RE: **Proposed Kaiser Development**
Former Chevron Service Station #9-1026
3701 Broadway
Oakland, California

Cambria Environmental Technology, Inc. (Cambria) proposes the following additional scope of work in response to your May 1, 2006 letter (Attachment A) for the site referenced above (Figure 1). The proposed work is to be performed in lieu of the April 2006 *Waste Profile for Disposal Workplan*.

Subject: Fuel Leak Cases RO500 and RO205, 3701 and 3741 Broadway, Oakland,
CA 94611 (Proposed Kaiser Development)

FIGURE
2

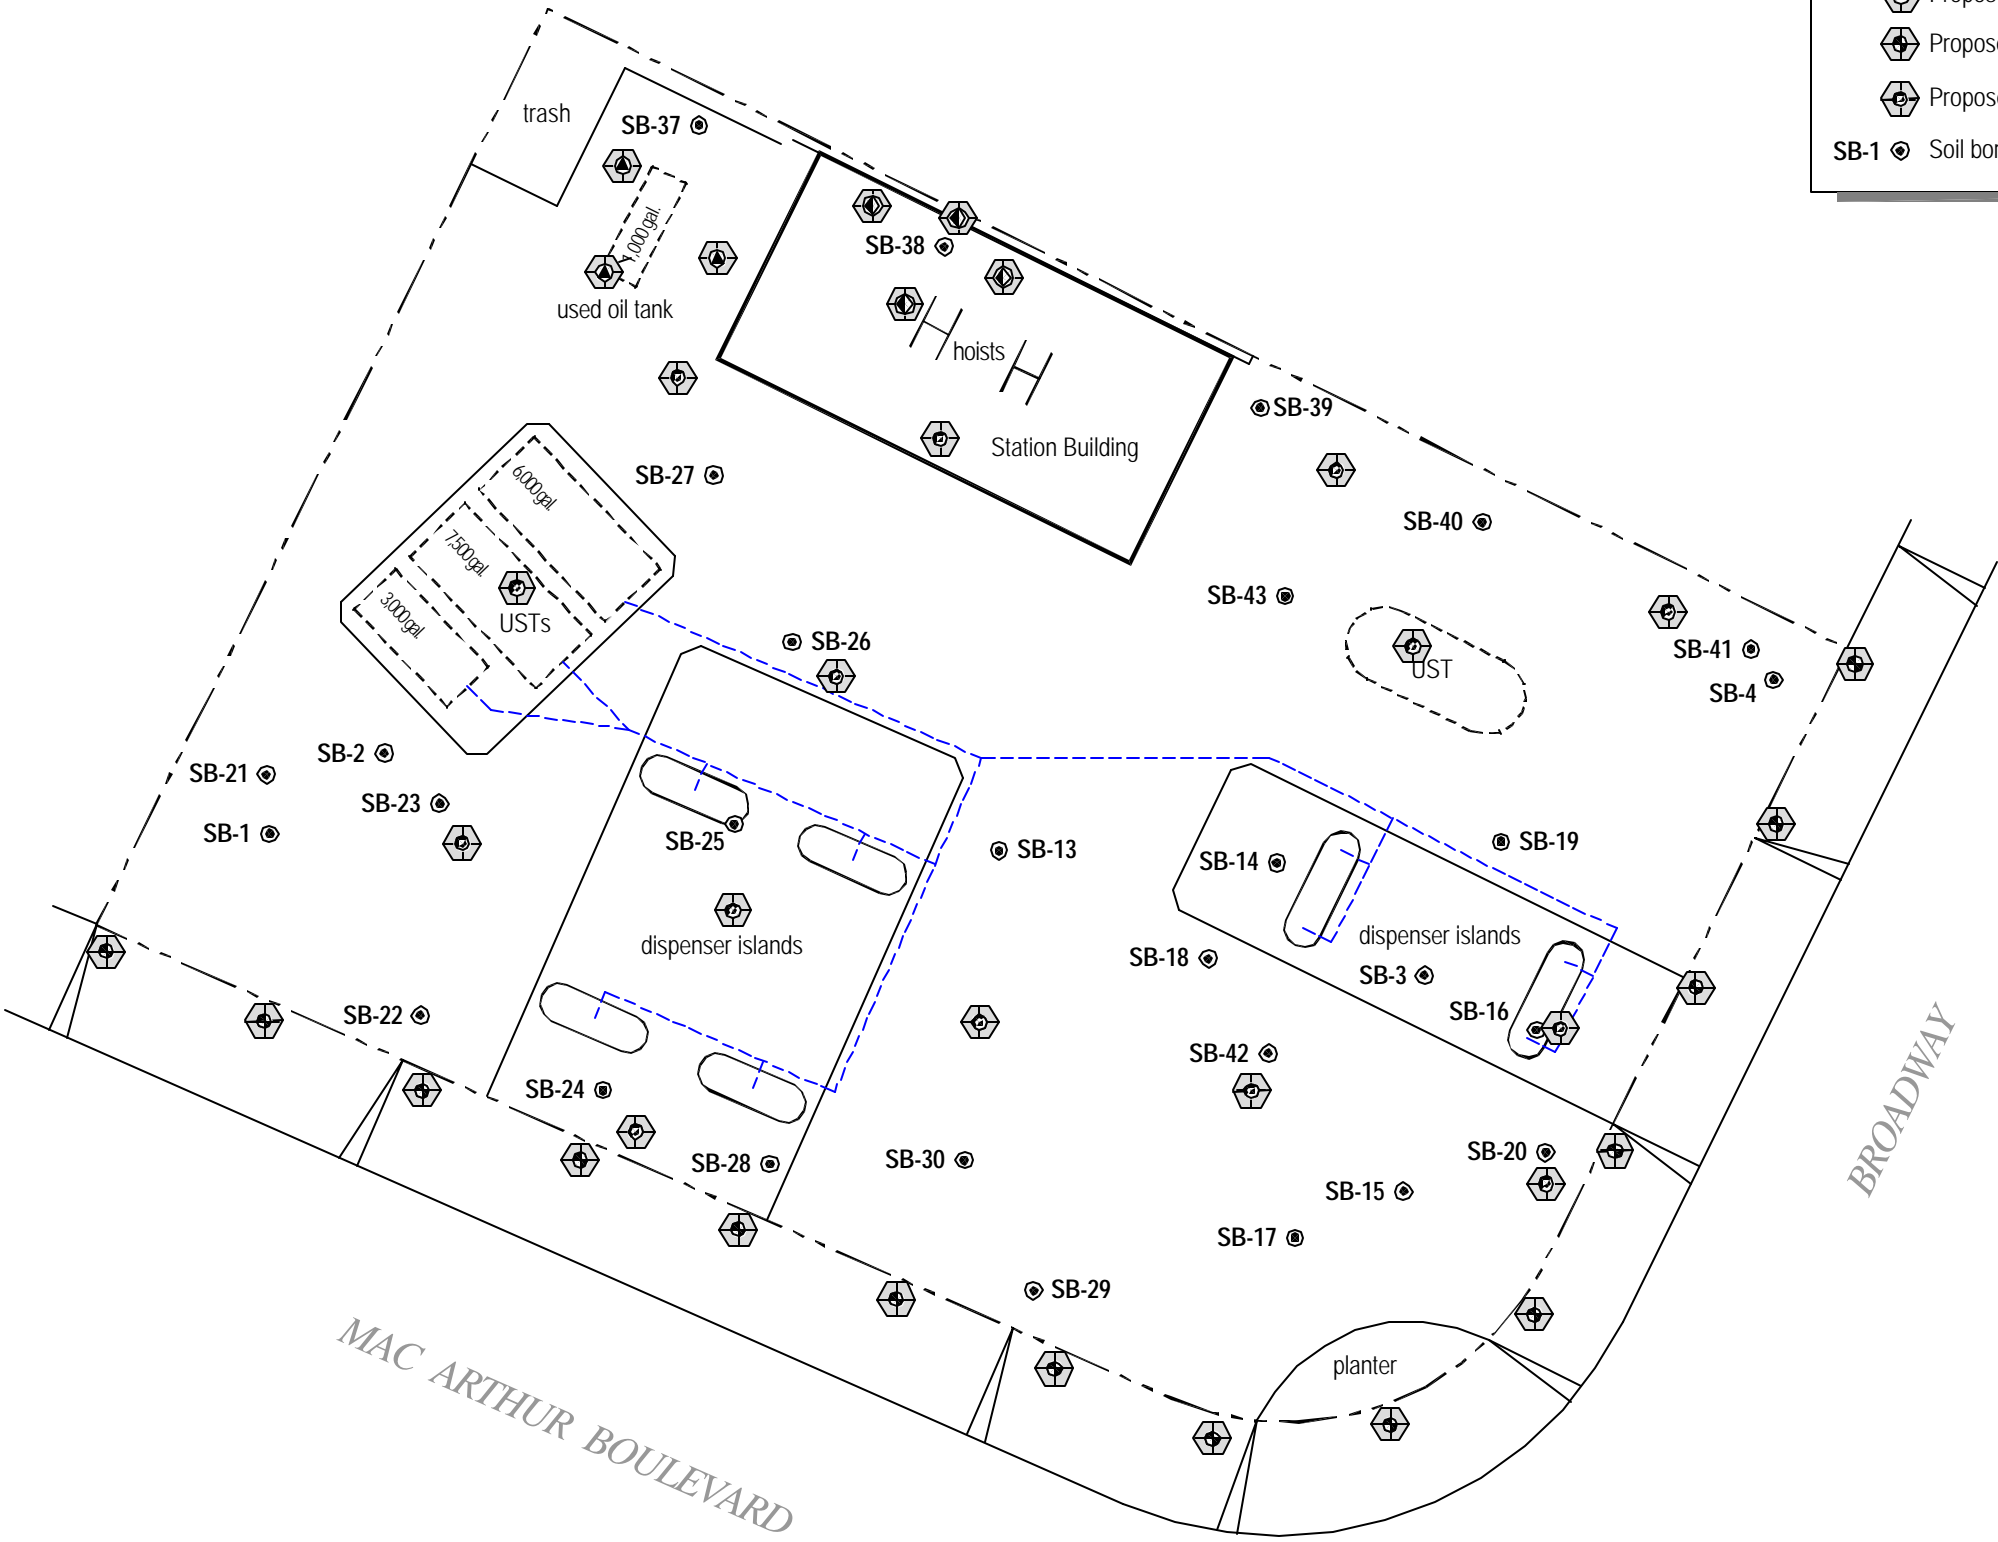
- How will the vertical extent of contamination be determined, particularly in the locations where concentrations appear to be increasing with depth and where these concentrations exceed cleanup levels?

- The inability to collect sidewall confirmation samples poses a problem when attempting to estimate risk to occupants of the proposed subsurface building. There is a potential that the floor confirmation samples will underestimate actual residual concentrations. An attempt to estimate sidewall samples should be done, possibly at some intermediate stage of the excavation. Please provide a supplemental sampling proposal.

Vertical Delineation of Hydrocarbons in the Subsurface: Cambria will advance 15 soil borings using a direct push drill rig within the proposed excavation limits to delineate the vertical extent of hydrocarbons in the subsurface. Borings will be advanced at locations where previous concentrations were detected above Regional Water Quality Control Board (RWQCB) environmental screen levels (ESLs) at depths greater than 18 feet below grade (fbg) (Figure 2). Soil samples will be collected between 18 and 30 fbg at five-foot intervals or where odor and/or staining are indicative of hydrocarbon impact. Additional samples will be collected from these borings between 0-20 fbg to profile soils for disposal. Four samples from each boring will be collected, two samples between 0-10 fbg and two samples between 10-20 fbg. These samples will be combined to create three four-point composites for each depth interval, and submitted to the laboratory as waste profile samples. Secor's March 6, 2006 *Site Characterization Report* indicated that lead was detected at 1,500 mg/kg in a sample collected from SB-38 at 4.5 fbg. Therefore, borings to 10 fbg will be advanced in the vicinity of SB-38 to define the extent of lead in soil (Figure 2).

Alternative to Sidewall Sampling: To facilitate calculation of hydrocarbon mass left in soil beyond the site perimeter after excavation, Cambria will advance 14 soil borings to 20 fbg along the sidewalk on MacArthur Boulevard and Broadway (Figure 2). Borings will be advanced approximately every 20 linear feet along the sidewalk and sampled at five-foot intervals.

FIGURE **3**

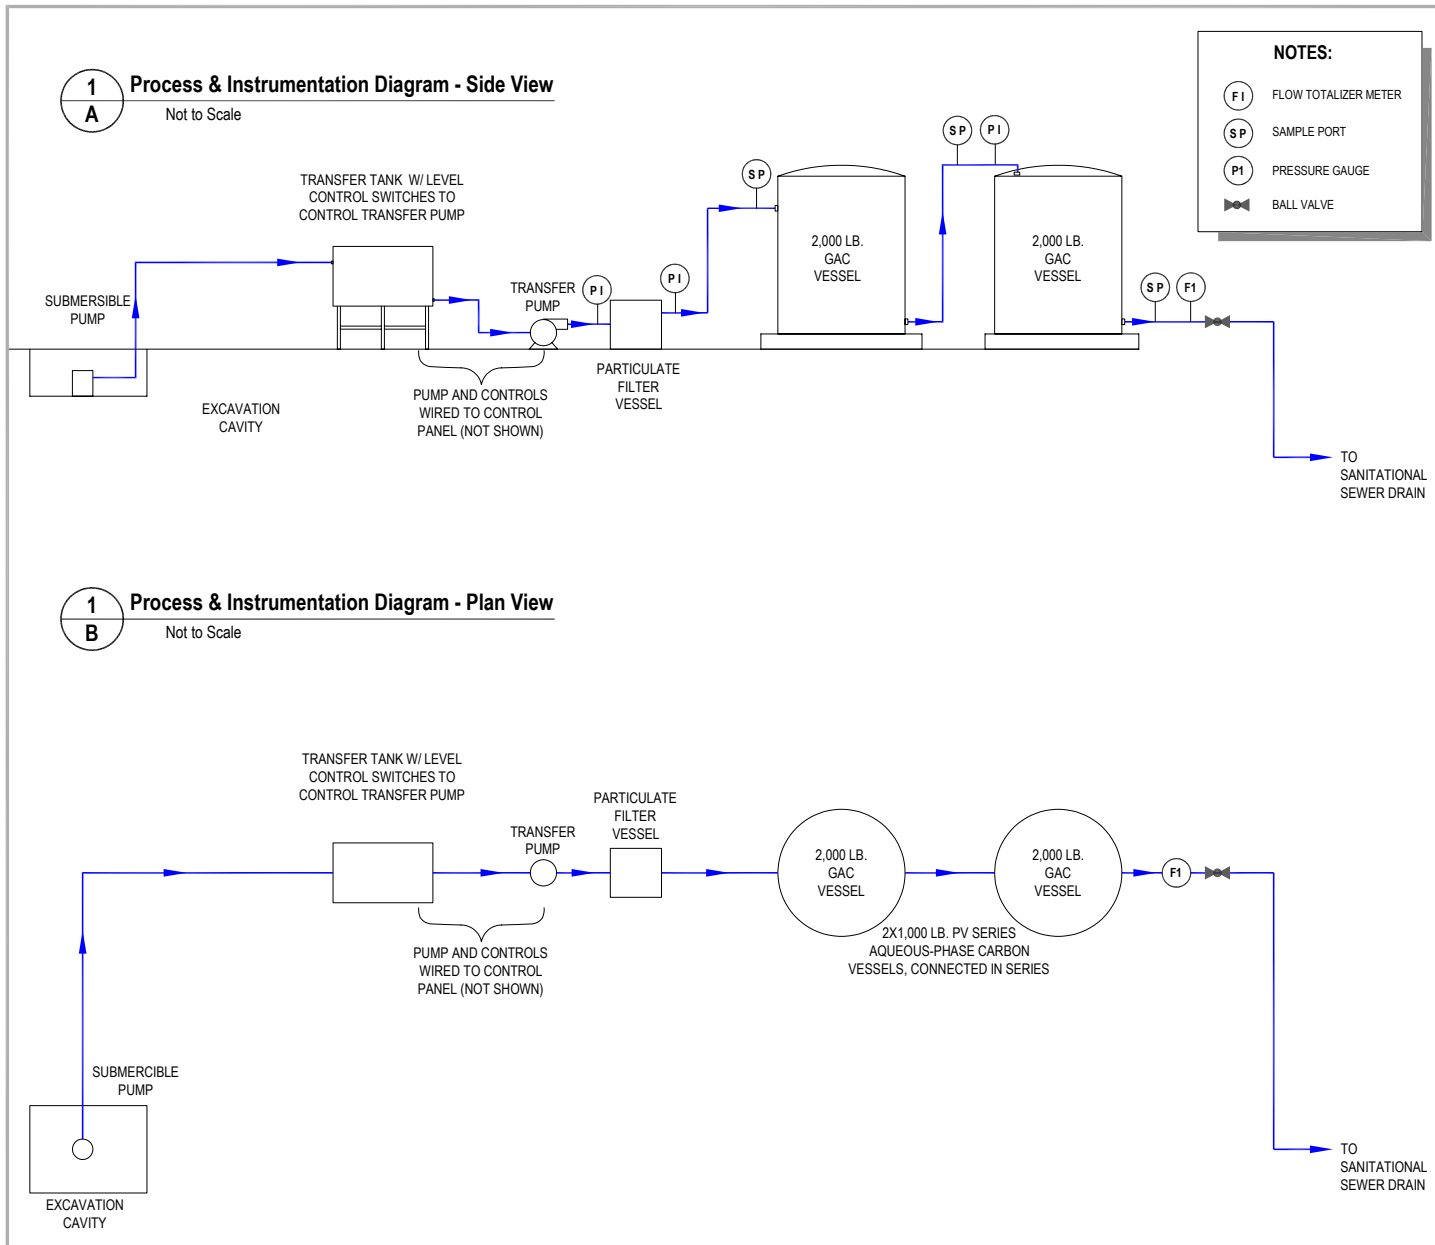
- Please provide a diagram of the proposed drainage system. Please indicate how the source areas were identified and how they will be treated by the drainage system. How and with what frequency will groundwater be sampled? Will the system allow preferential drainage from specific areas? What will determine the duration of the groundwater removal system?

Proposed Dewatering System: The dewatering system will be designed to facilitate excavation activities below the water table. The system will not be designed to remediate groundwater as a long term pump-and-treat system. Therefore, source areas are not a concern nor will they be specifically targeted for groundwater removal. Groundwater extracted during excavation will be pumped into a 20,000-gallon holding tank with a submersible electric pump installed at the lowest point of the excavation. Suspended sediment in the extracted groundwater will be allowed to settle in the holding tank. Once sediment has settled out, groundwater will be pumped through the treatment system consisting of a particulate filter and two 2,000-pound activated carbon vessels connected in series. Treated water will then be discharged into the sanitary sewer under permit from East Bay Municipal Utility District (EBMUD). Groundwater discharged to the sewer will be quantified by a totalizer flow meter installed on the discharge line (Figure 3). We have designed the system to handle up to 100 gallons per minute. The actual flow rate is likely to

far less once the excavation has been dewatered. Groundwater influent and effluent concentrations will be sampled as required by the EBMUD discharge permit.
